L-PI-09-110
TS 5.6.5.d

Prairie Island Nuclear Generating Plant Unit 1
Docket 50-282
License No. DPR-42

Core Operating Limits Report (COLR) for Prairie Island Nuclear Generating Plant (PINGP) Unit 1, Cycle 26, Revision 0

**PRAIRIE ISLAND NUCLEAR GENERATING PLANT
CORE OPERATING LIMITS REPORT
UNIT 1 – CYCLE 26
REVISION 0**

Figure 1

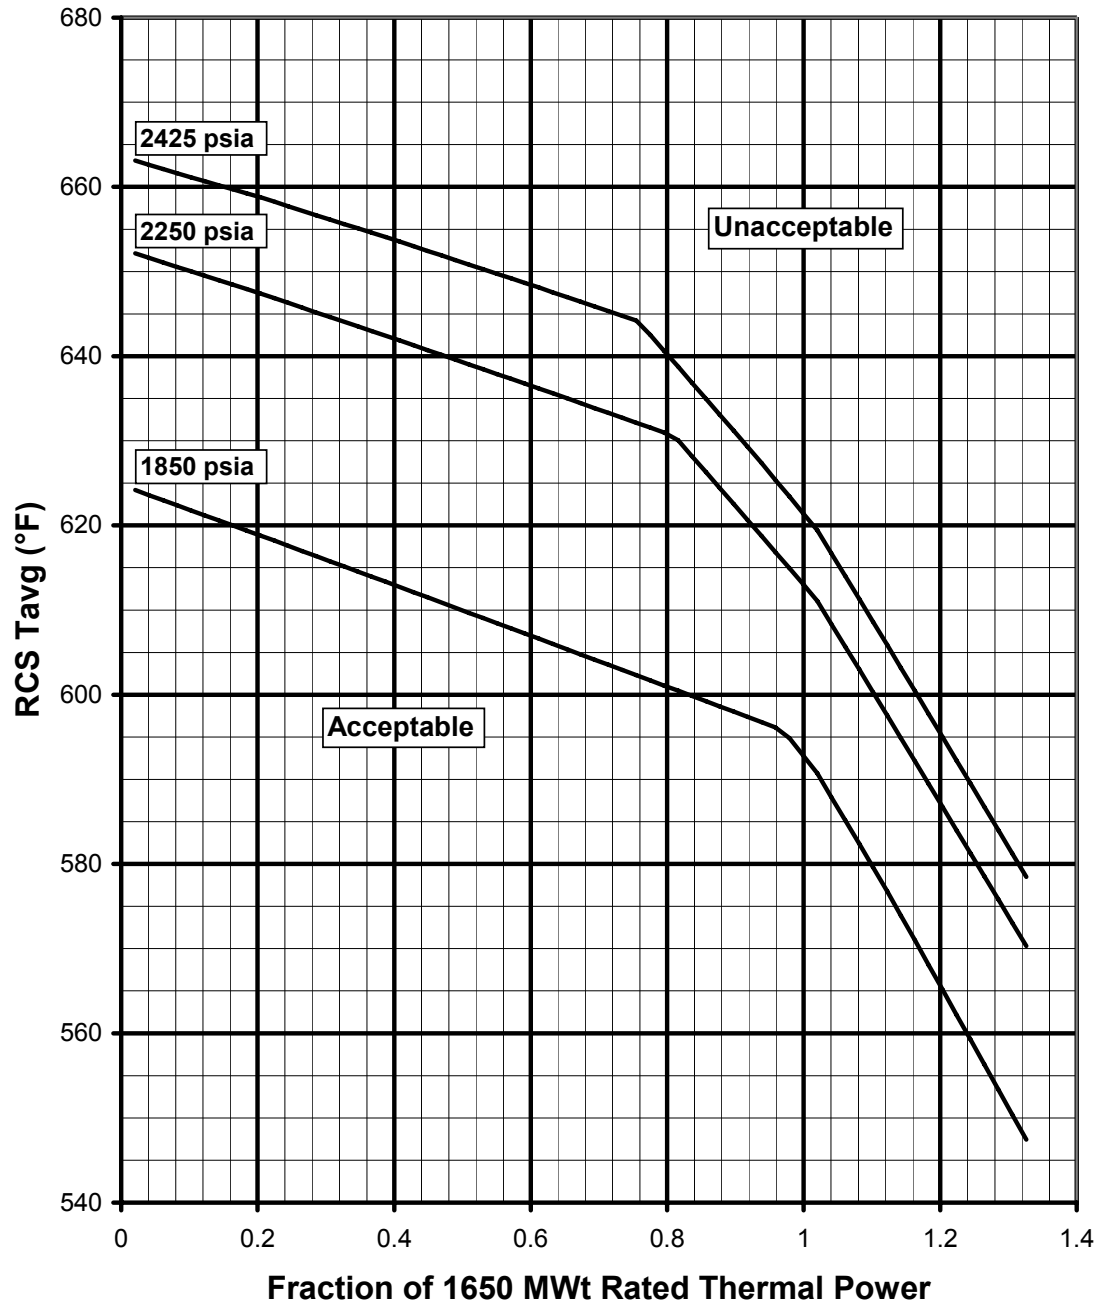
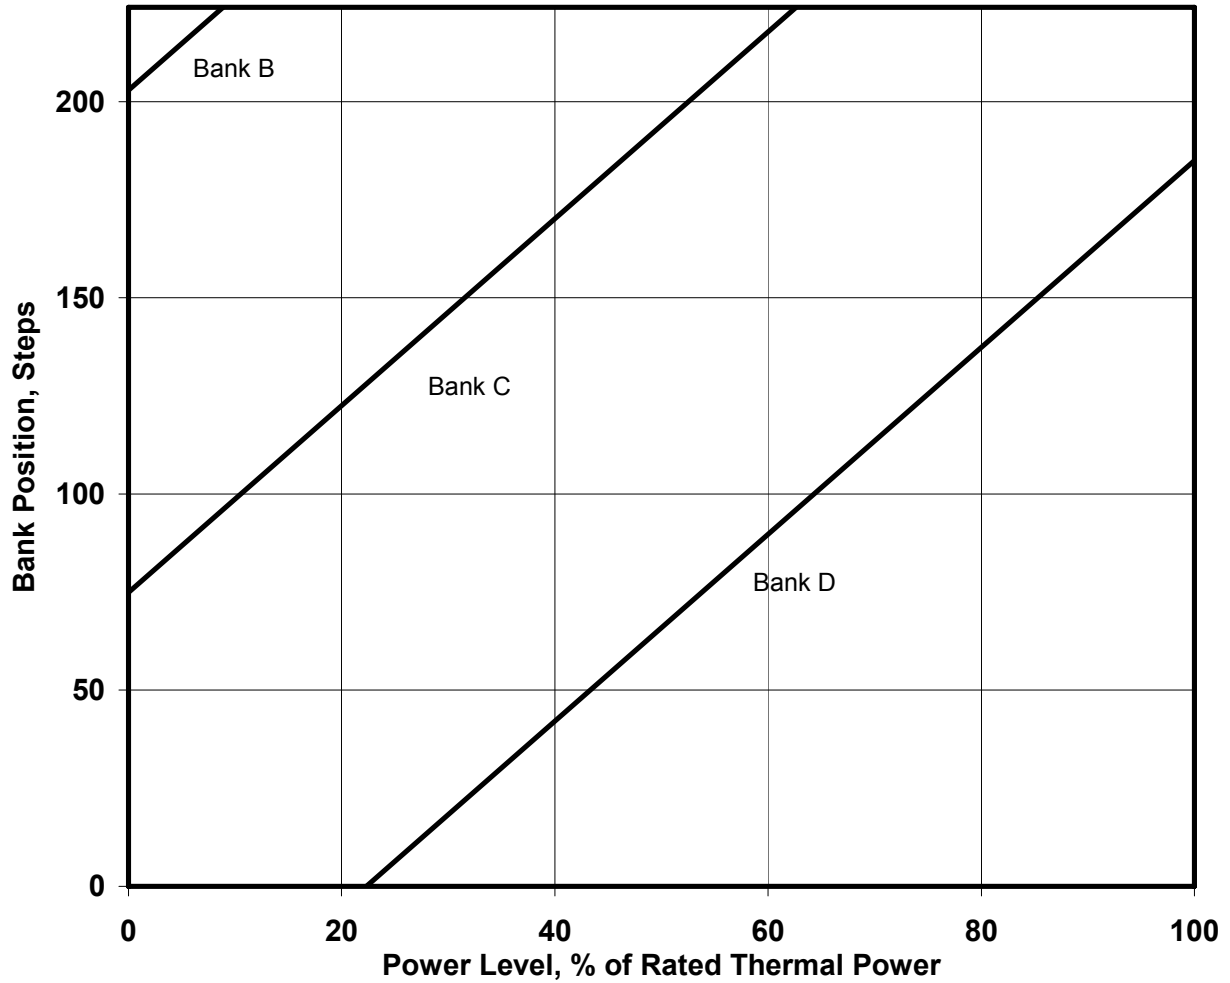
- Revised Figure 1, Reactor Core Safety Limits, for Unit 1, Cycle 26.
